# ALERT SERVICE BULLETIN

SUBJECT: FLIGHT CONTROL SYSTEM - Main Rotor Controls

Removal of the swashplate bellows and retrofit of the deflection ring of the swashplate

Revision 5, 2017-07-25 PAGE 1 of 20

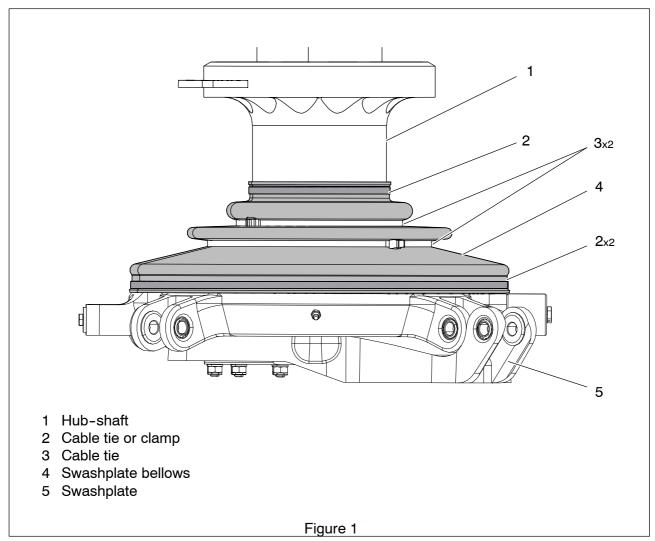
- (a) Remove the cable ties or clamps (2, Fig. 1) and cable ties (3) from the swashplate bellows (4).
- (b) Remove the swashplate bellows (4, Fig. 1) from the swashplate (5) and from the hub-shaft (1).
- (c) Discard the swashplate bellows (4, Fig. 1).

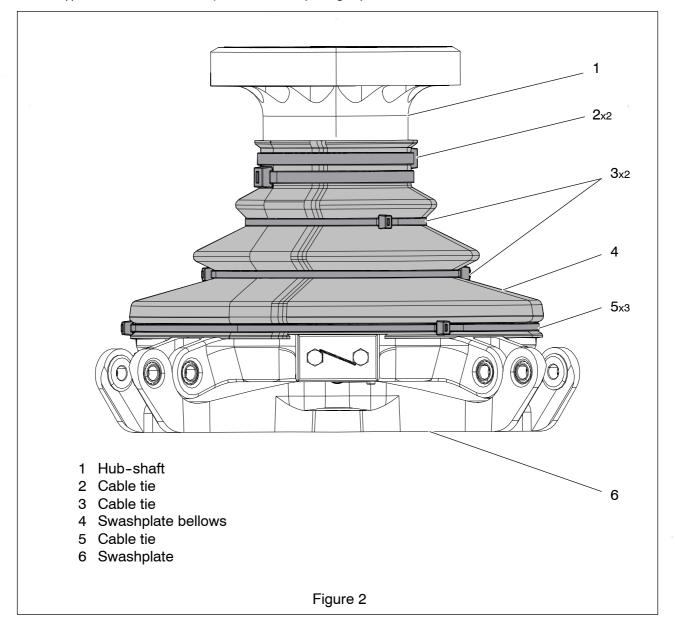
- (d) Remove the cable ties (2, Fig. 2), cable ties (3) and cable ties (5) from the swashplate bellows (4).
- (e) Remove the swashplate bellows (4, Fig. 2) from the swashplate (6) and from the hub-shaft (1).
- (f) Discard the swashplate bellows (4, Fig. 2).

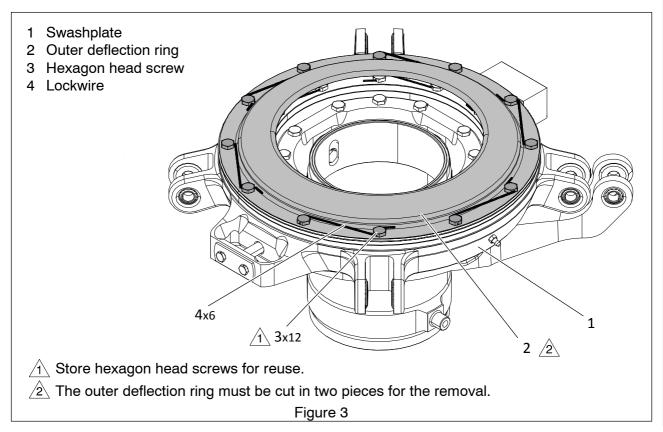
- (a) Remove the lockwire (4, Fig. 3) from the hexagon head screws (3).
- (b) Remove the twelve hexagon head screws (3, Fig. 3) from the swashplate (1). Store the hexagon head screws (3) for reuse.

- (c) Protect the swashplate (1, Fig. 3) with a cloth.
- (d) Cut the outer deflection ring (2, Fig. 3) in two pieces using a metal snips or a suitable tool.
- (e) Remove the outer deflection ring (2, Fig. 3) from the swashplate (1).
- (f) Discard the outer deflection ring (2, Fig. 3).

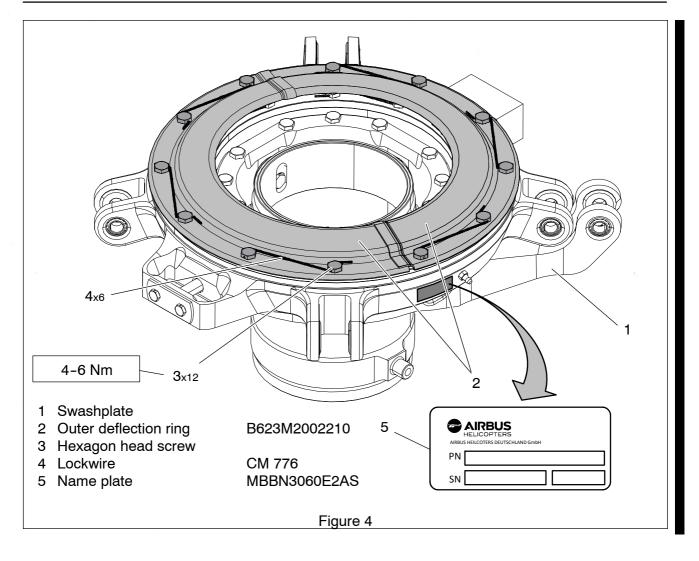
- (g) If there are unwanted objects in the area where the old deflection ring was installed, remove the unwanted objects. Remove dirt with a lint-free cloth.
- (h) Position both parts of the new outer deflection ring (2, Fig. 4) on the swashplate (1), refer to Fig. 4.
- (i) Install both parts of the new outer deflection ring (2, Fig. 4) with twelve hexagon head screws (3). Torque the hexagon head screws (3) to 4–6 Nm (36–53 lbf.in).
- (j) Secure the Hexagon head screws (3, Fig. 4) with lockwire (4) (CM 776).

(I) Write the P/N "105-41904-001" on the new name plate (5, Fig. 4) using a wiping resistant pen.

(m) Write the P/N "105-41905-001" on the new name plate (5, Fig. 4) using a wiping resistant pen.

- (n) Copy the S/N from the old name plate to the new name plate (5, Fig. 4) using a wiping resistant pen.
- (o) Cross out the old P/N on the old name plate.
- (p) Apply a layer of lacquer (CM 481) to the old name plate. Let lacquer dry i.a.w manufacturer's instruction.
- (g) Install the new name plate (5, Fig. 4) close to the old name plate to the swashplate (1).
- (r) Apply a layer of laquer (CM 481) to the new name plate (5, Fig. 4). Let laquer dry i.a.w manufacturer's instruction.

- (s) Use a wiping resistant pen, identify the swashplate close to the name plate (5, Fig. 4) as follows: "ASB BO105-40A-107".
- (t) Protect the identification with lacquer, single-layer (CM 421). Leave lacquer, single layer dry, refer to the manufacturer's instructions.

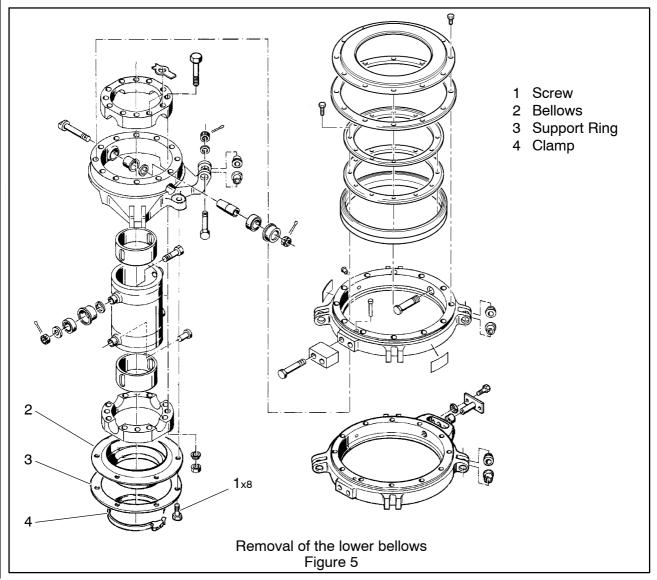
- (a) Remove the lock wire from the screws (1, Fig. 5).
- (b) Remove the screws (1, Fig. 5) from the swashplate.
- (c) Remove the clamp (4, Fig. 5) from the lower bellows (2).
- (d) Cut the support ring (3, Fig. 5) in two pieces using a metal snips or a suitable tool.
- (e) Cut the lower bellows (2, Fig. 5) using a suitable tool.
- (f) Remove the lower bellows (2, Fig. 5) and the support ring (3) from the swashplate.
- (g) Discard the lower bellows (2, Fig. 5), the support ring (3) the clamp (4) and the screws (1).

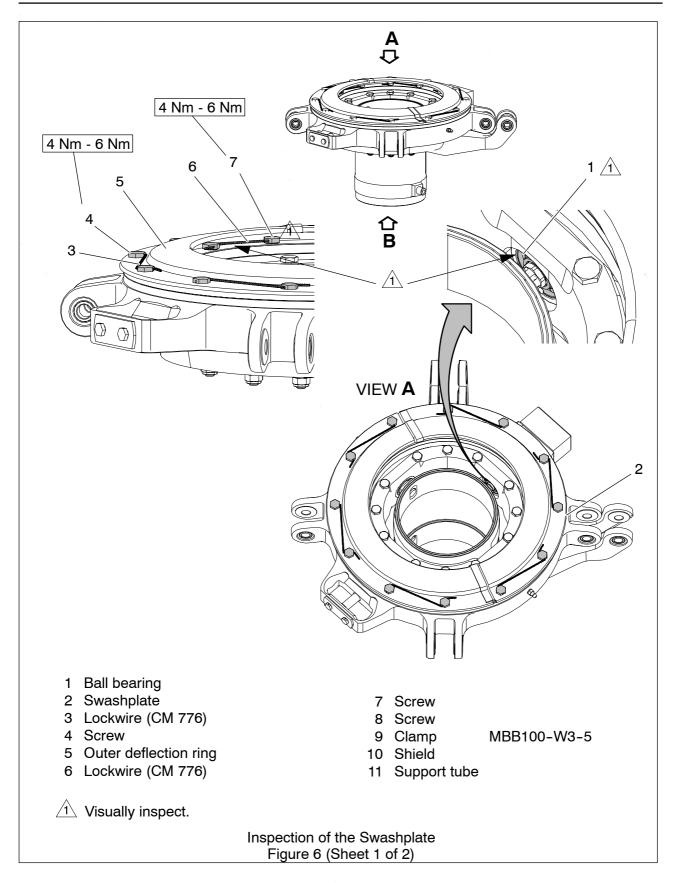
- (a) Do the inspection of the swashplate bearing, refer to MM, 41-73.
- (b) Lubricate the swashplate bearing, refer to MM, 41-74.
- (c) Do the inspection of the area under the outer deflection ring (5, Fig. 6) as follows:
  - 1 Remove the lockwires (3, Fig. 6) from the screws (4).
  - 2 Remove the screws (4, Fig. 6).
  - 3 Remove the outer deflection ring (5, Fig. 6).
  - 4 If there are foreign objects, remove the foreign objects.
  - 5 Remove dirt with a lint-free cloth.
  - 6 Install the outer deflection ring (5, Fig. 6) with the screws (4).
  - 7 Apply a torque between 4 Nm and 6 Nm to the screws (4, Fig. 6).
  - 8 Safety the screws (4, Fig. 6) with new lockwire (CM 776) (3), refer to MTC, 20-02-06-402.
